Re: PA 89-25 Hardee Power Station Post Certification - Hardee to Vandolah
Transmission Line Incompleteness Response.

HARDEE POWER STATION
CERTIFICATION PA 89-25

POST CERTIFICATION INCOMPLETENESS RESPONSE

FIGURE 16

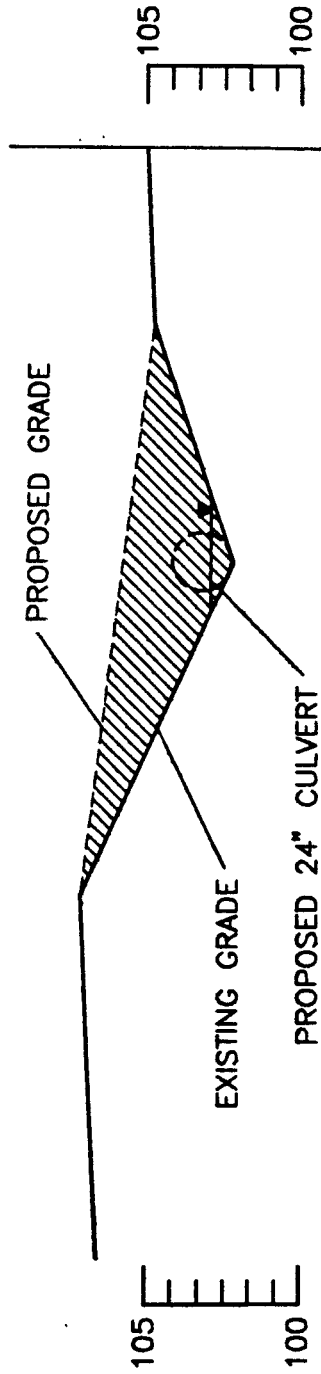
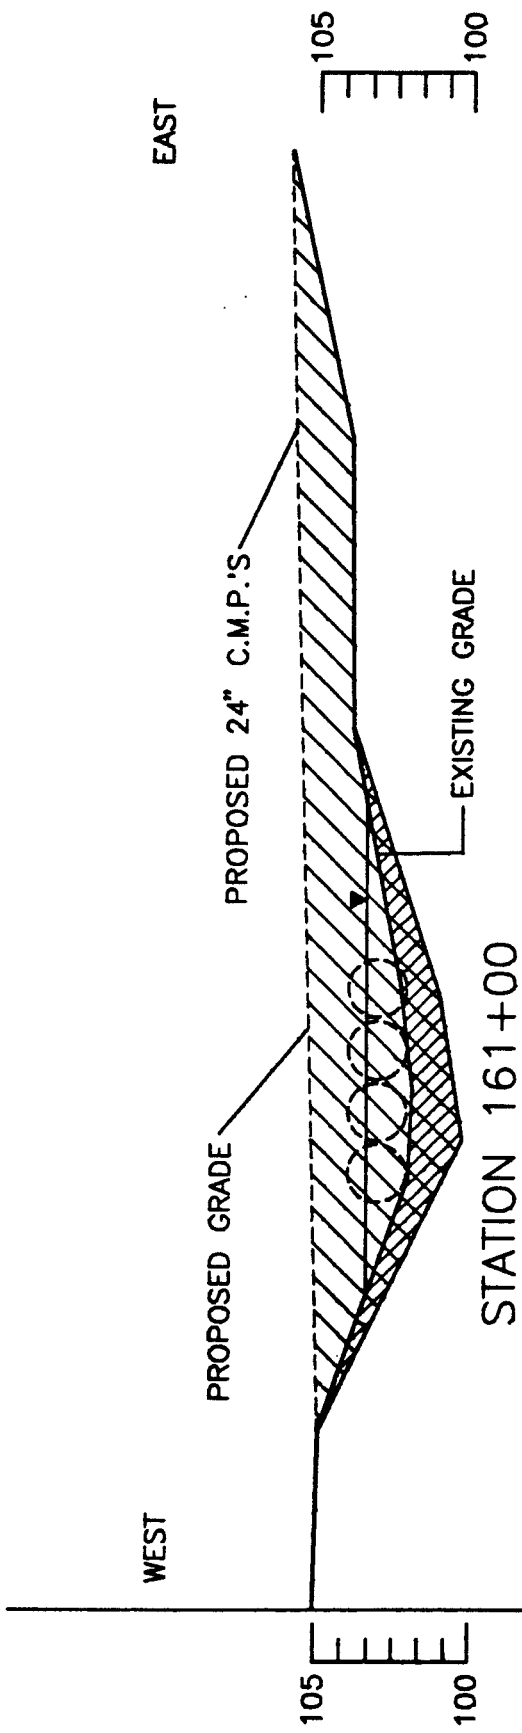
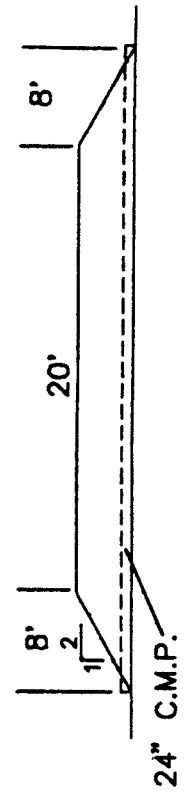
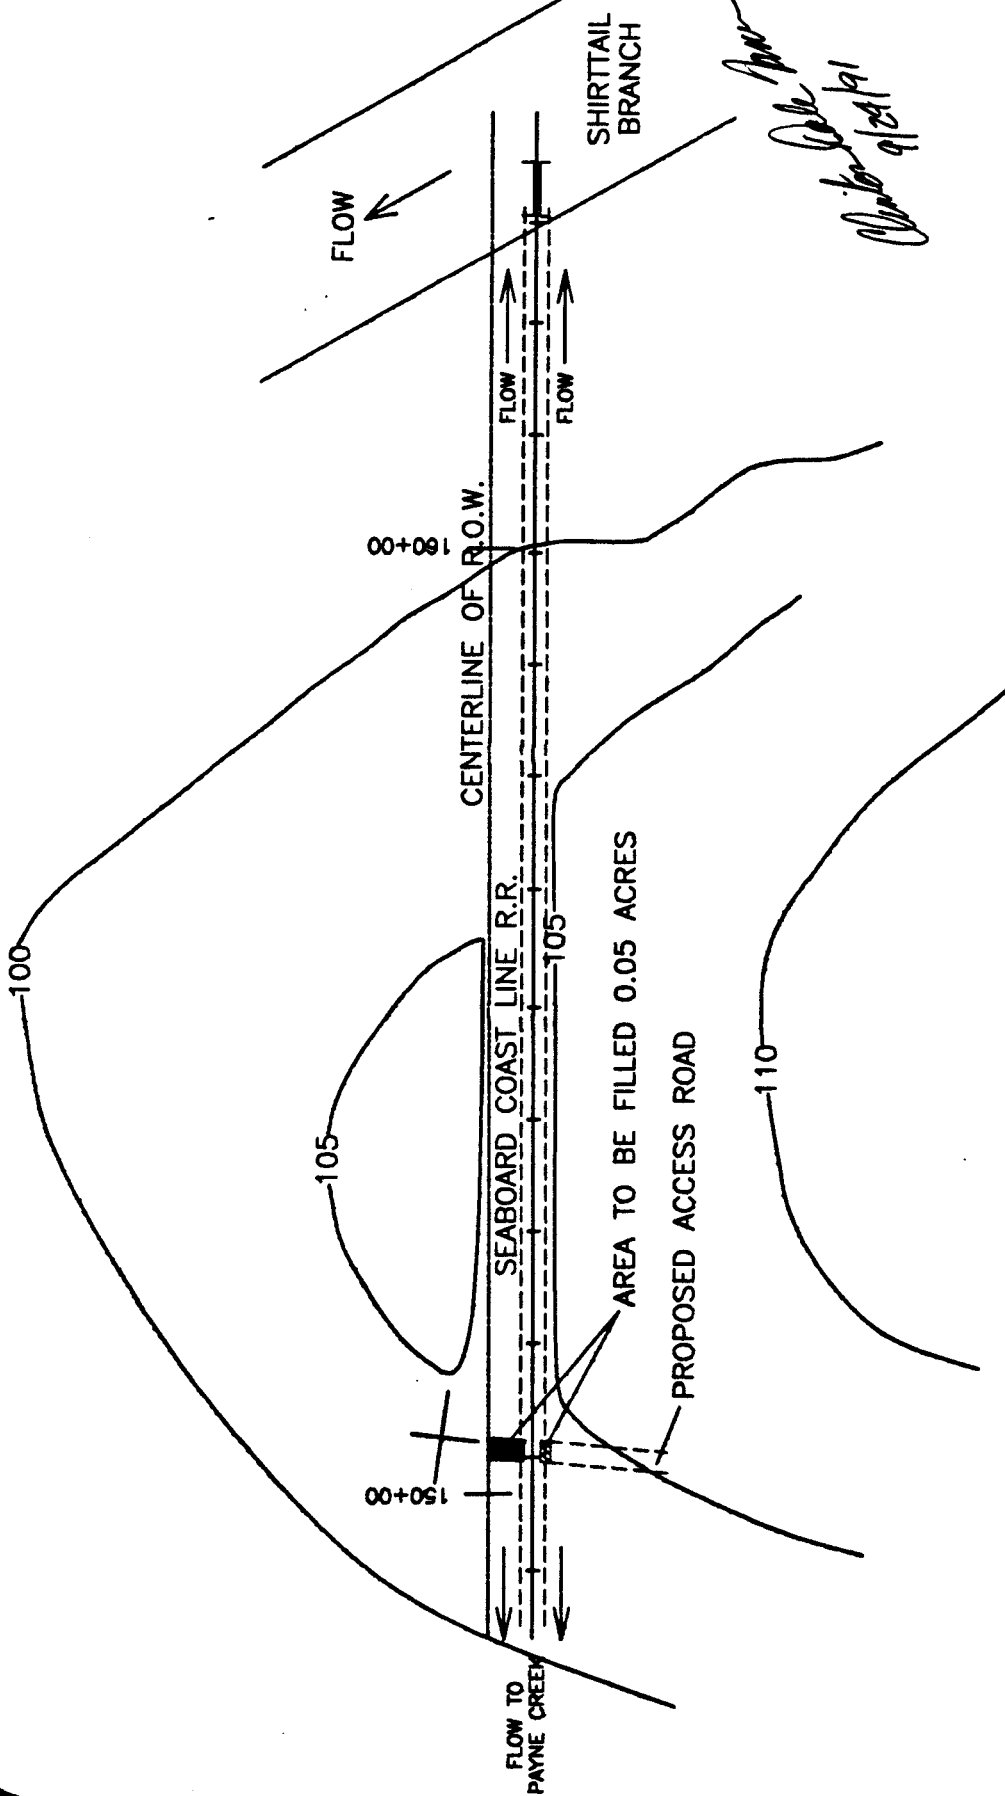
14. Figures 14, 15, and 16 appear to be related. If this is correct, please revise them to show clearly how they are related. If this is not correct, please show to what Figure 14 and 15 are related.

As shown in Figure 16, the figures show a railroad ditch adjacent to Shirttail Branch. In order to minimize impacts to Payne Creek and Shirttail Branch, we have been able to achieve access to the south side of Payne Creek via a road that will require culverts to cross the railroad ditch. Additional labeling, including station numbers have been added to the revised figures.
